# NuScale DC Application Design Basis Failed Fuel Fraction Issue

September 2017

# Comparison of Failed Fuel Percentages

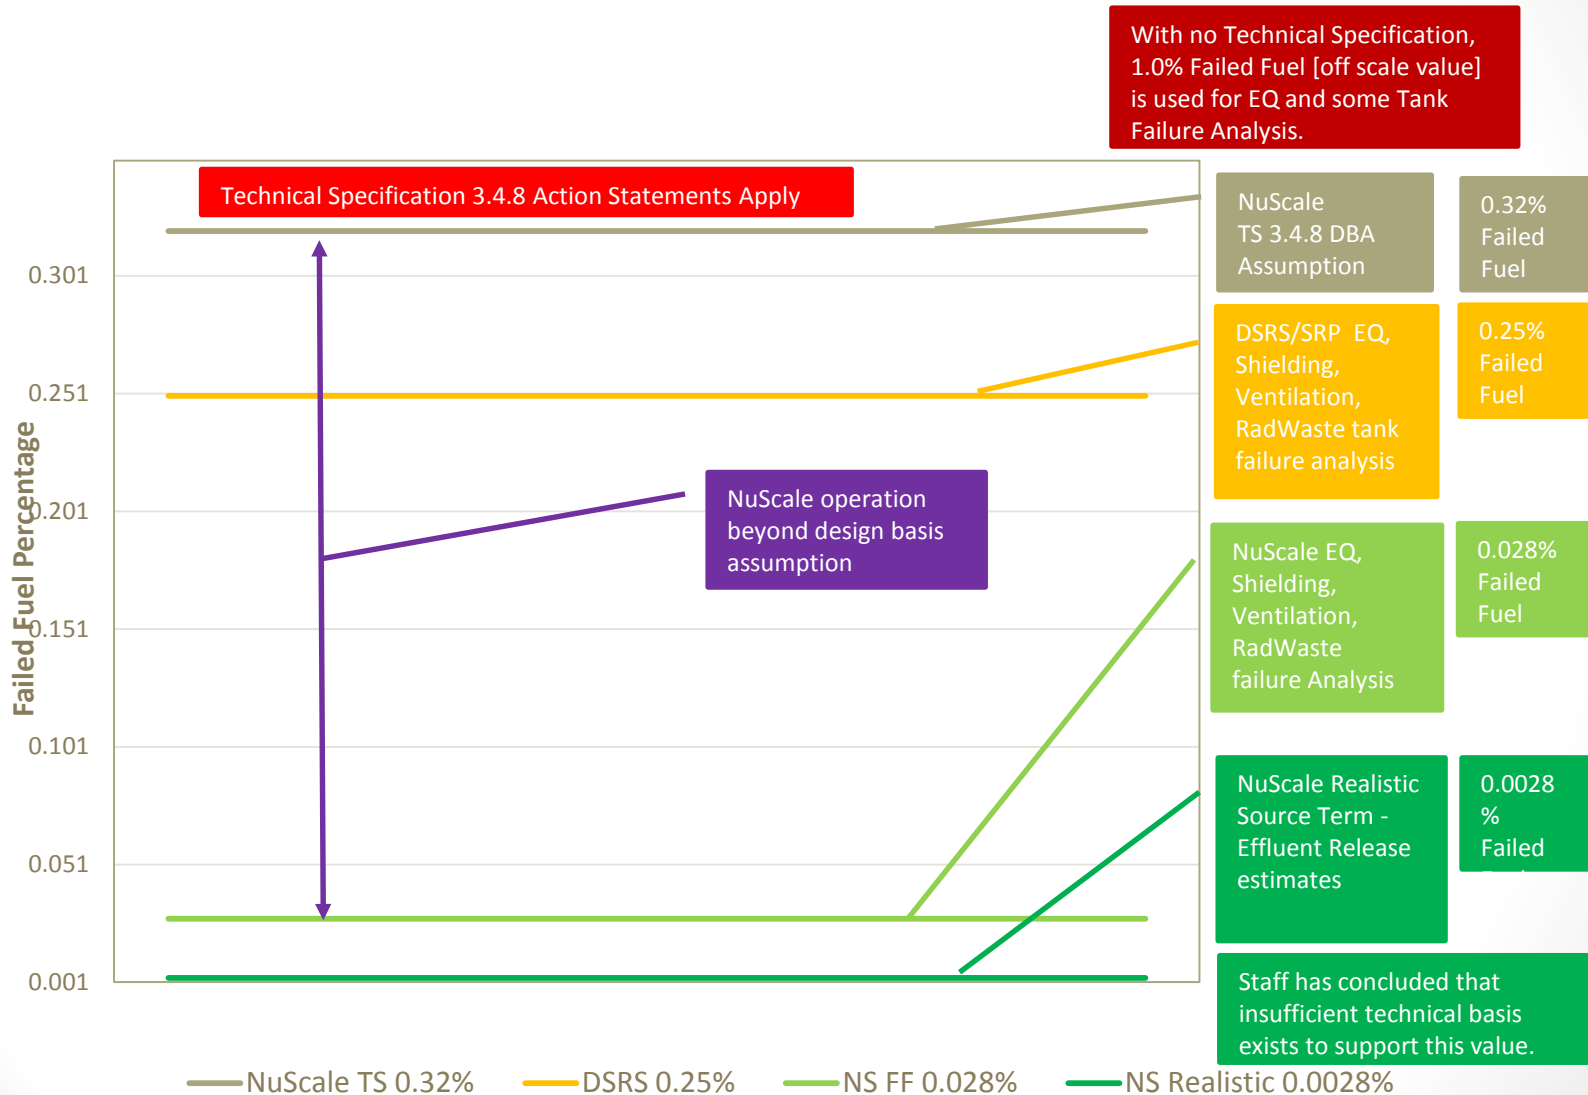
- NuScale's approach deviates from that approved for all operating reactors and previous design certifications which include a TS that encompasses the design basis failed fuel fraction

- All operating reactors and design certification applications have assumed 0.25% failed fuel as an assumption in the design of radiation protection design features (higher values for EQ analyses)

- The lower design basis failed fuel fraction is credited in the NuScale design for ensuring that regulatory requirements are met, including 10 CFR Part 20 requirements

- NuScale has not provided sufficient information to justify the proposed design basis failed fuel fraction
  - The derivation, including method and data used, of the design basis failed fuel fraction is not technically sufficient
  - Factor of 10 provides less absolute margin when compared to the higher failed fuel fraction assumed for currently licensed plants
- NuScale has not provided sufficient justification to support the direct applicability of operating reactor failed fuel experience to the NuScale design
  - Fuel and core design is different (first of a kind)
  - No operational experience or fuel performance testing with this design
  - Unique manufacturing and operational challenges may occur due to first of a kind fuel design
